## Brisbane Central Business District Bicycle User Group

### **Submission on Brisbane City Council draft City Reach Waterfront Master Plan**

This submission provides the views of the Brisbane Central Business District Bicycle User Group (CBD BUG) on Brisbane City Council draft City Reach Waterfront Master Plan.

Figure 2 - Brisbane City Council advice stating HSW path should be segregated

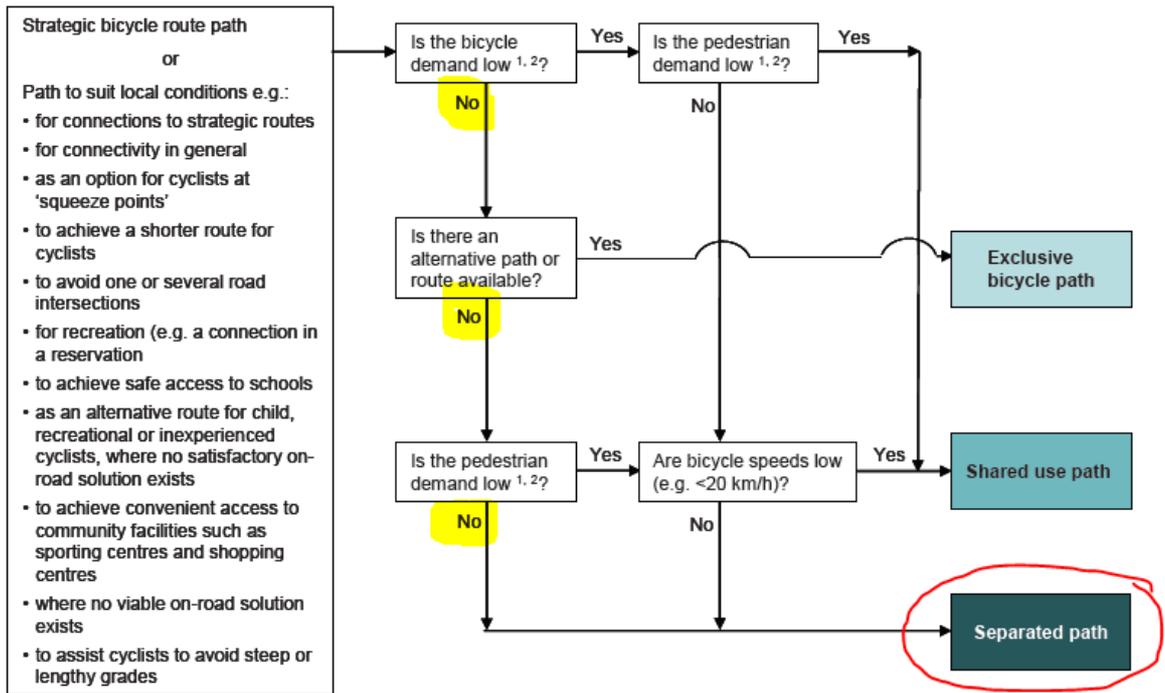
Nevertheless, we are extremely disappointed the current draft plan proposes the widened promenade would continue to be shared by people walking and cycling, instead of segregating this space to enhance safety and amenity for cyclists and pedestrians. Such a proposal contradicts previous advice that Brisbane City Council has provided to Howard Smith Wharves (Figure 1) and Queens Wharf (Figure 2). The proposal for shared use instead of segregation also contradicts AustRoads Part 6a (figure 3). The flow diagram on page 7 (of AustRoads document) clearly shows a segregated path as preferred.

The Howard Smith Wharves Nominees' consistent desire for the shared pathway not to have an overt through movement function is acknowledged. The issues raised have been discussed with Council's Public and Active Transport team and Transport technical specialists. They have confirmed that Council's position remains consistent in requiring the through movement function of cyclists and pedestrians to be apparent to all users of the site, since it forms part of the Riverwalk linking New Farm to the CBD that is intended to have a significant people movement function.

The plan amendments specified are aimed at ensuring that all users of Howard Smith Wharves are aware of the important through movement function the link provides and to facilitate its safe operation, while allowing some flexibility in movement across the site. Concessions have been given to the form of the facility at the high-level approval stage, by permitting a shared pathway arrangement **in lieu of desirable segregated facilities**, and a relatively short shared zone with reduced speed limit in the constrained areas adjacent to the hotel pick up/ drop-off and service bay.

Figure 4 – Brisbane City Council City Plan 2014

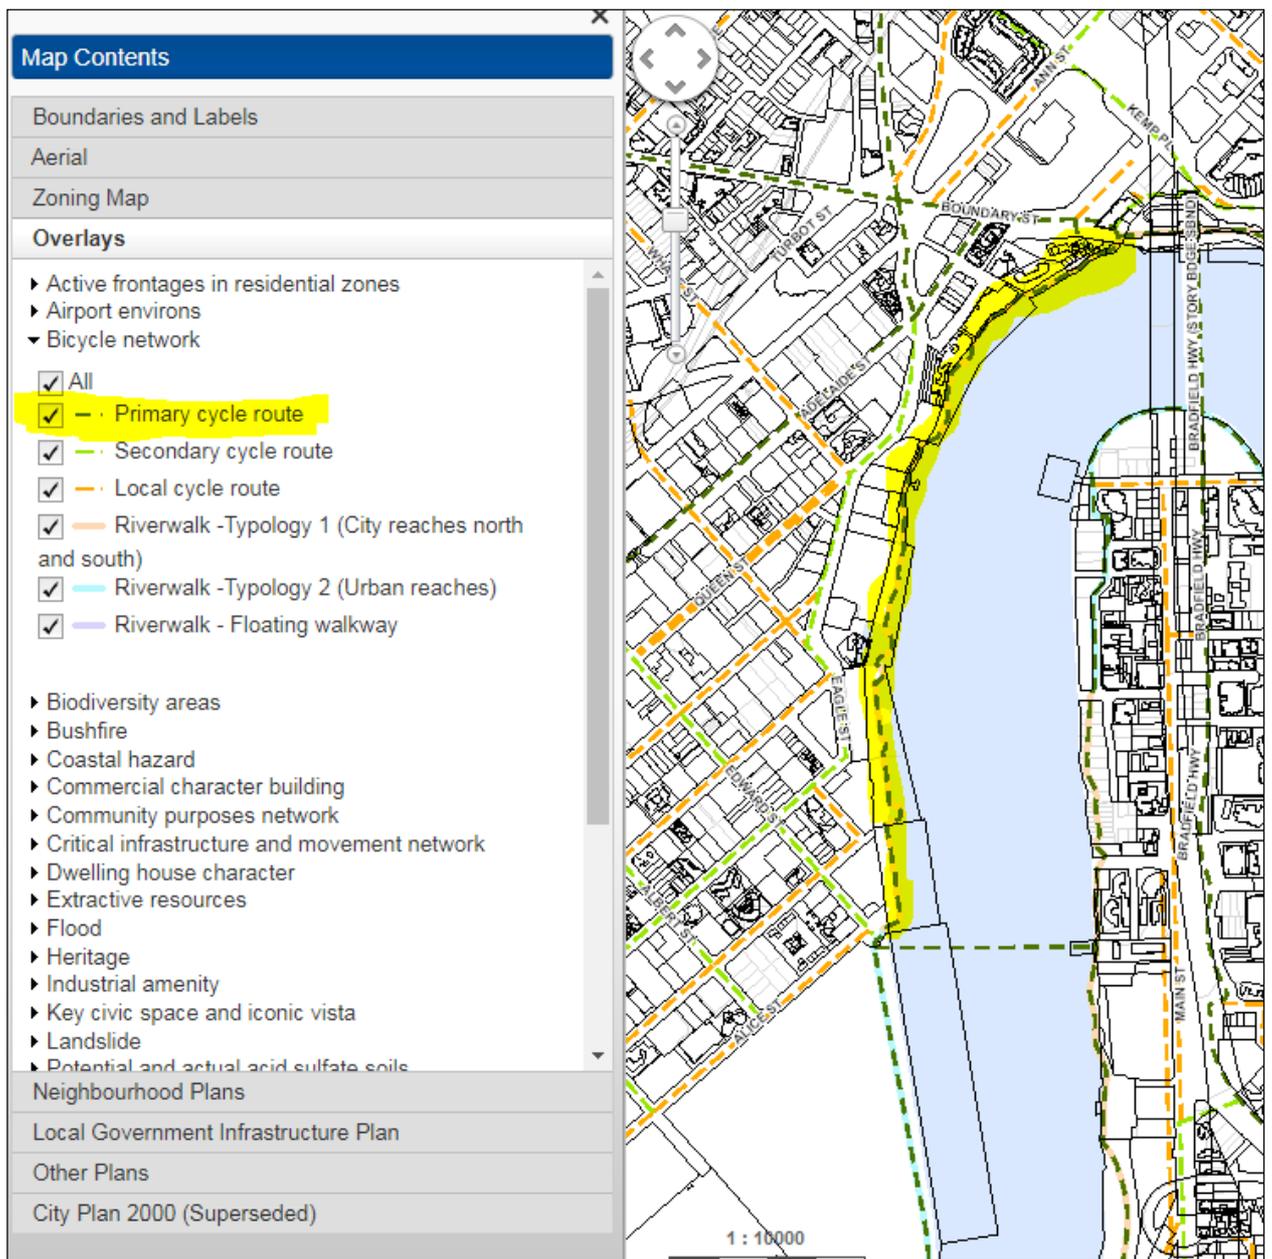
Whether a Brisbane CBD minimum grid of protected bikelanes is installed or not, this promenade will remain a key route for cyclists for the foreseeable future! Many people want to ride for transport but are too intimidated by Brisbane's hostile road environment and a corridor such as the promenade resolves this barrier. It should be pointed out that both Brisbane City Council and Transport and Main Roads list this as a "Primary Cycle Route" (Figure 4) and "Route Priority A" (Figure 5) respectively. The TMR document indicates that the Cityreach Boardwalk Promenade is to complement the proposed CBD bike lanes and not be a replacement for them.
